GE Licensing Topical Report NEDO-32906-A, Revision 1,
“TRACG Application for Anticipated Operational Occurrences
(AOO) Transient Analyses

**TRACG Application
for
Anticipated Operational Occurrences (AOO)
Transient Analyses**

SUBJECT: SAFETY EVALUATION REPORT ON GENERAL ELECTRIC NUCLEAR ENERGY TOPICAL REPORT NEDE-32906P, REVISION 0, "TRACG APPLICATION FOR ANTICIPATED OPERATIONAL OCCURRENCES (AOO) TRANSIENT ANALYSES," (TAC NO. MA7779)

Figure 1 Comparison of Radial Power Distributions for two Methods used in the Analysis

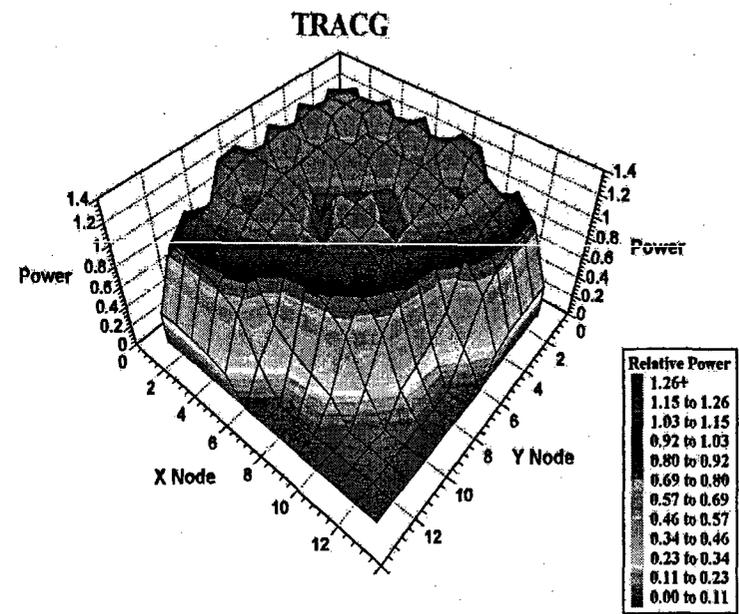
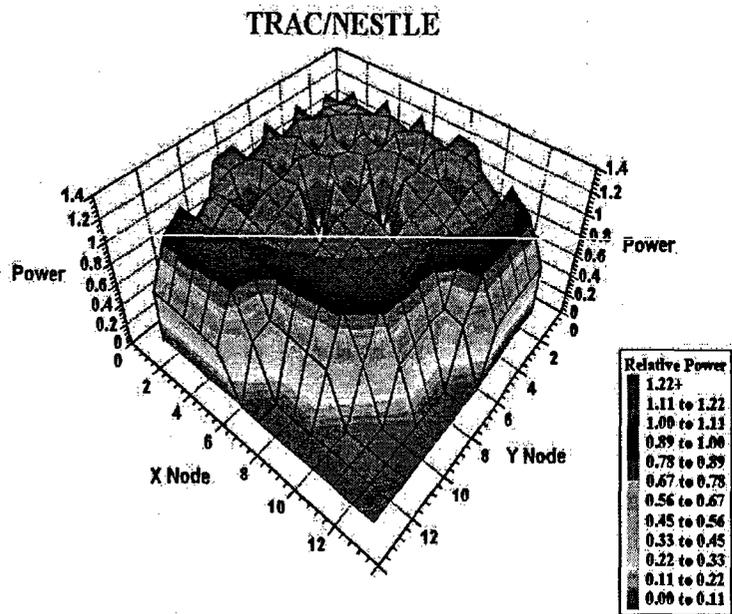
The staff and GNF predictions of the two fuel type core are compared in Figures 1 and 2. Figure 1 shows a three-dimensional view of the initial steady state power distribution and Figure 2 shows the infinite eigenvalue as a function of time for the two fuel types used in the core. One difference between the two predictions in Figure 1 is the fact that the staff results are not as smooth as the GNF analyses. This difference is typical when comparing modern nodal methods to finite difference methods, possibly because nodal methods attempt to more accurately account for inter-assembly gradients. Otherwise, Figure 1 demonstrates that the two methods quantitatively agree well with one another. Figure 2 shows that the void reactivity input into the two respective kinetics codes is equivalent.

Figure 5 Total Reactor Power for Simulated Pressurization Transient

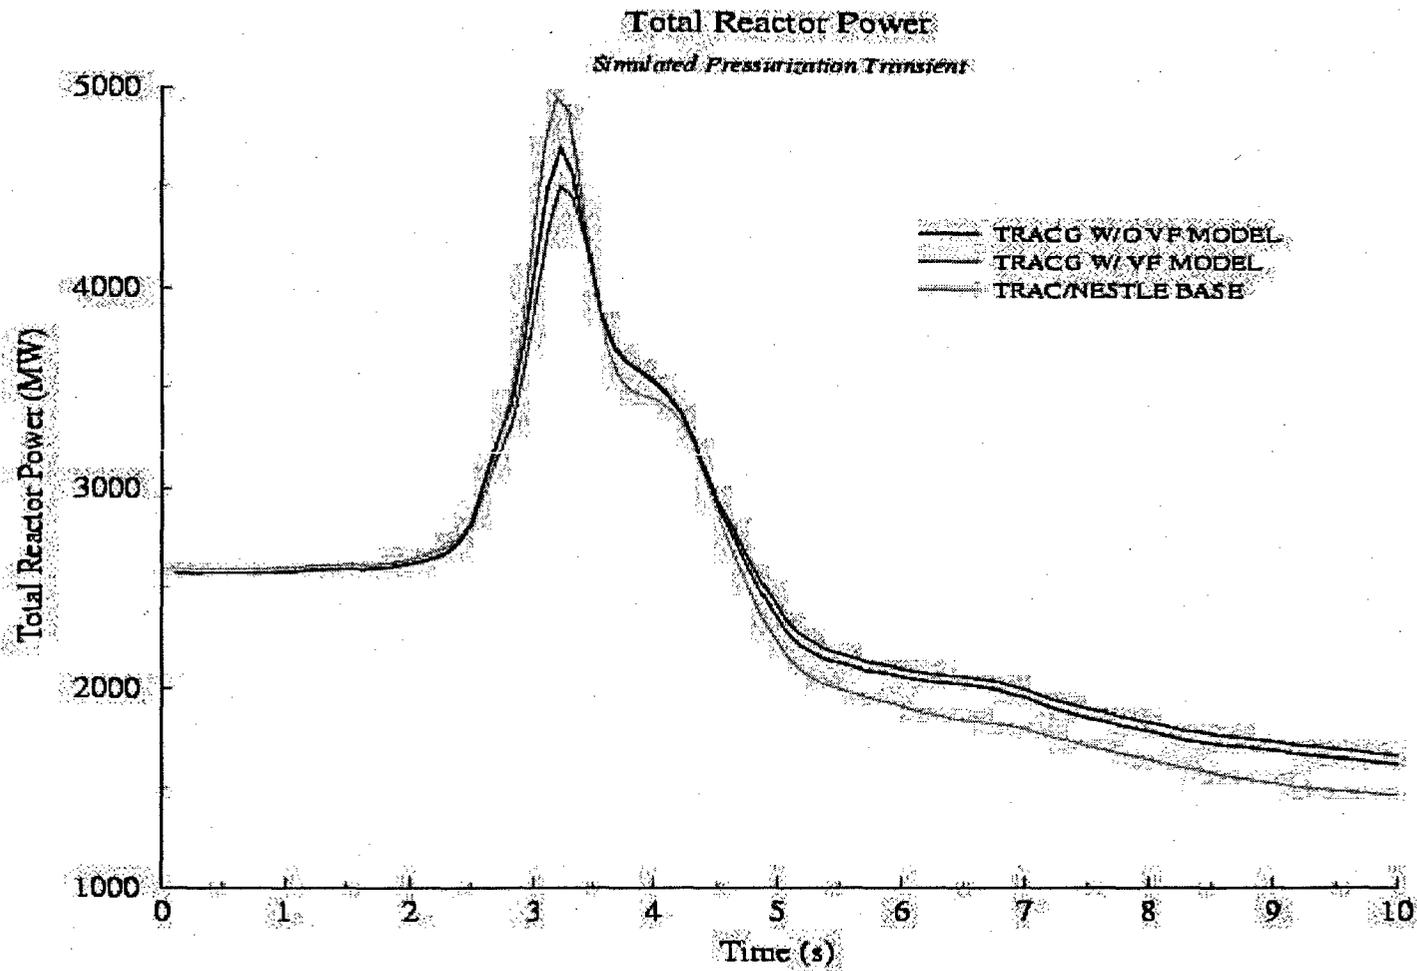
As one can see from the previous section, the staff spent considerable effort attempting to reconcile the differences between the TRACG and the TRAC/NESTLE independent assessment results. In the end this work focused on understanding the PIRT18 model. As one can see from Figure 5, it does significantly affect the peak power. However, after considering that the proposed application of TRACG is to AOO analyses, the staff concluded that this effect on peak power is not significant because when the peak is under-predicted, the global reactivity balance will force the tail to be over-predicted and TRACG has been shown to adequately predict the global reactivity balance. This has the affect of compensating for the effect that the PIRT18 model has on the key parameter of interest from the kinetics solver in AOO analyses, which is energy. Energy, not power, drives changes in critical power ratio. As one can see from Figures 7 and 8 both codes predict similar energy deposition. Figure 7 shows the energy as a function of time and Figure 8 shows the relative difference in energy as function of time between TRACG and TRAC/NESTLE. The staff has, therefore, determined that although the basis for this model has not been well established, its effect on AOO transient results will be minimal as demonstrated in Reference 9. In this evaluation, the affect of the PIRT18 model on the Δ CPR/ICPR results has been shown to be insignificant. This model will have to be reassessed and better justified should GNF desire to use it for RIA analyses.

Returning to the discussion of Figure 5, the staff results and the TRACG results are in reasonable agreement. Although the TRACG results without the PIRT18 model agree better with the staff results, the results with the PIRT18 model are acceptable when one considers the following:

1. TRACG compares well with the Peach Bottom turbine trip tests. Although these tests were not as limiting as the transient considered in the test problem and the Peach Bottom core used older BWR fuel that was easier to analyze, the results do provide evidence that TRACG adequately simulates pressurization transients; and
2. The TRACG results, when compared to the staff's results, do not differ significantly enough to affect predictions of Δ CPR/ICPR values. This is true because as mentioned earlier critical power is a function of energy deposition, not power.

Figure 6 Comparison of Different Monte Carlo Evaluations of the Same GNF Lattice

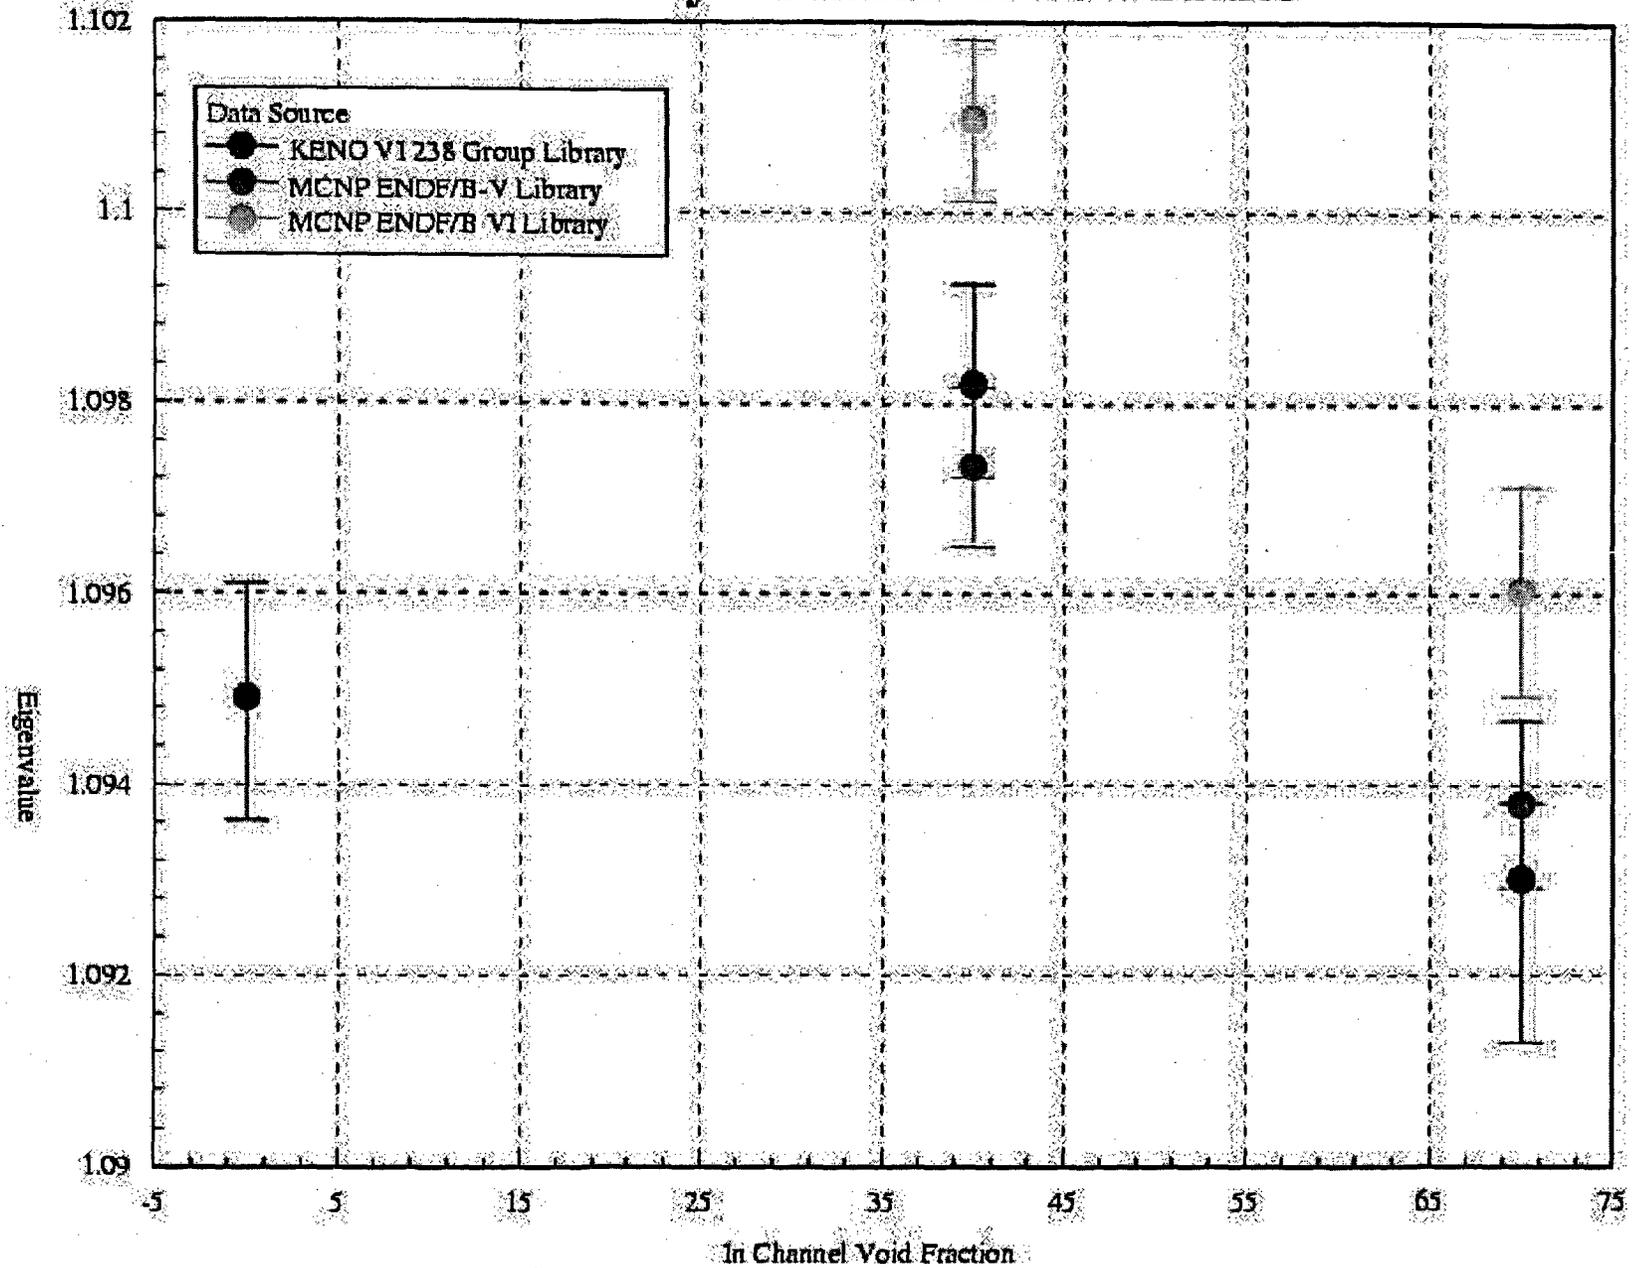
The staff independently assessed this model because the TRACG results are sensitive to it. The staff ran many MCNP calculations of a GNF fuel lattice using different modeling assumptions and different cross sections based on ENDF/B-V and ENDF/B-VI data. The results of the assessment identified a weakness in the GNF model. The GNF model uses the MCNP code, which is a Monte Carlo solver, to predict point values. Monte Carlo methods do not yield point answers; rather, they provide statistically significant ranges of answers. As the staff results in Figure 6 show, a wide range of different, but statistically equivalent answers, can be attained by using different cross section formulations and different (but equivalent) modeling assumptions. *The differences presented in Figure 6 would not typically be of concern if it were not for the fact that BWRs are sensitive to void reactivity changes on the order of magnitude of the 95th percentile confidence intervals of the MCNP results.*

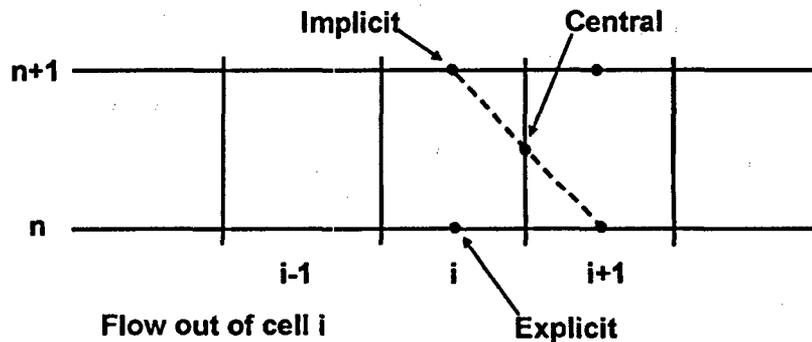
What is the effect of the "Central Difference Option Flag?" Describe the coding changes made to implement this option.

See the response to RAI 7 for details on which solver options are used. The effect that the hydraulic differencing schemes have on the coding is easiest to explain in terms of how it impacts the fluid property that is convected out of a cell. These impacts are illustrated below.

Figure 1 Total Reactor Power with unmodified TRACG

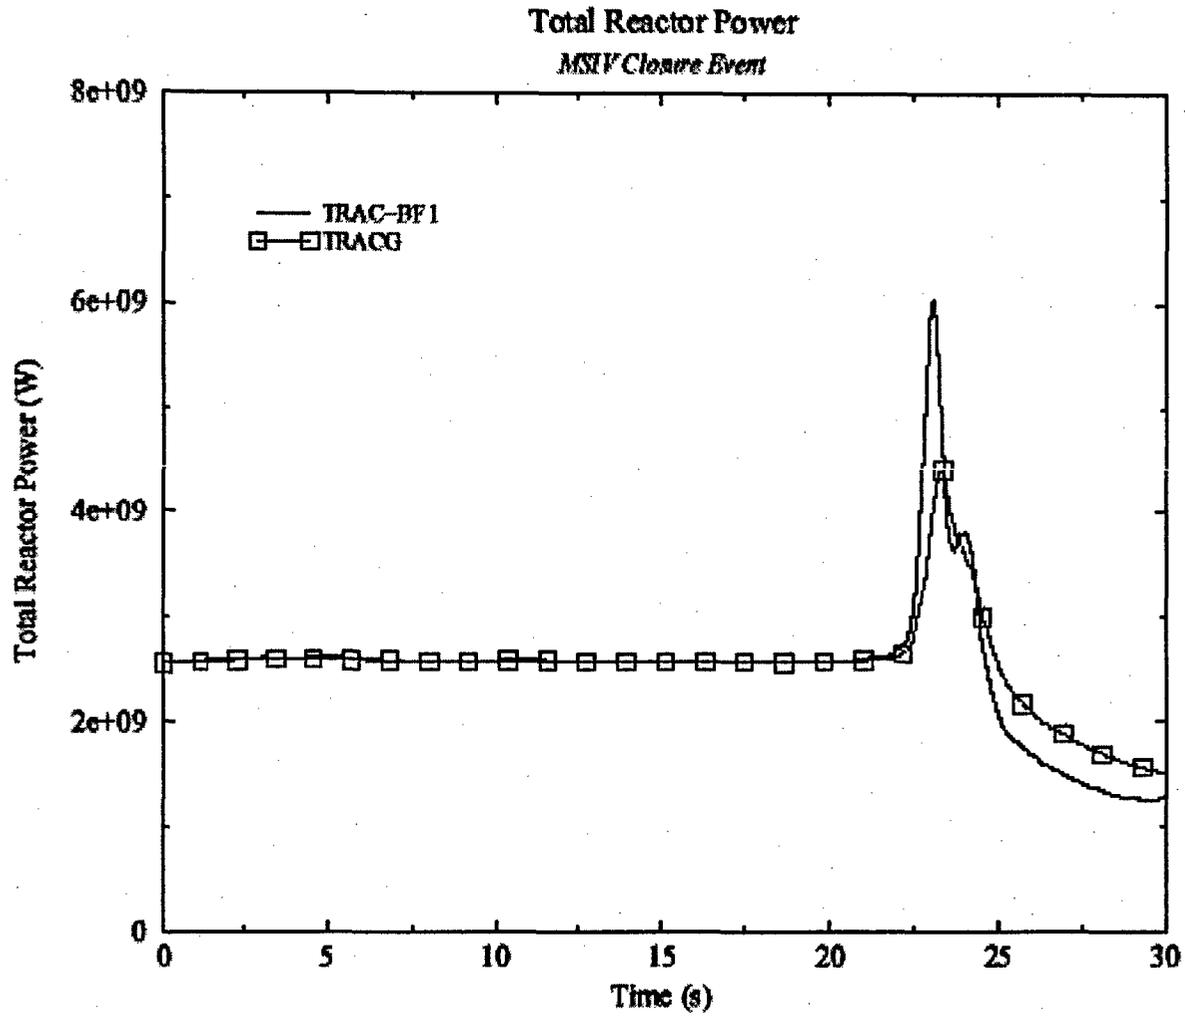
The staff has performed a series of audit calculations with TRAC-BF1 and NESTLE using the TRACG model provided by GNF. Analysis of a main steam isolation valve (MSIV) closure event with TRAC-BF1/NESTLE predicts a significantly different power when compared to TRACG (refer to Figure 1, attached). The staff has assessed both models and has not found any deficiencies in either the TRACG or the TRAC-BF1/NESTLE input. The boundary conditions, for example, are identical. In order for the staff to proceed with the review, the following information is needed to assist us as we attempt to reconcile the differences in the predicted results.

- a. Provide all of the calculated k-infinity values from the TGBLA code at the cross section generation branch points.*
- b. Describe the model used to account for the bypass and water rod density in the cross section formulation. How are changes in the bypass and water rod density accounted for in the cross section generation code and how are these effects averaged into a form suitable for TRACG analysis?*
- c. Describe the mathematical form of the cross section model and relate the coefficients in the TRACG kinetics output file to coefficients in the model.*
- d. Describe the form and content of the PANACEA wrap-up file.*
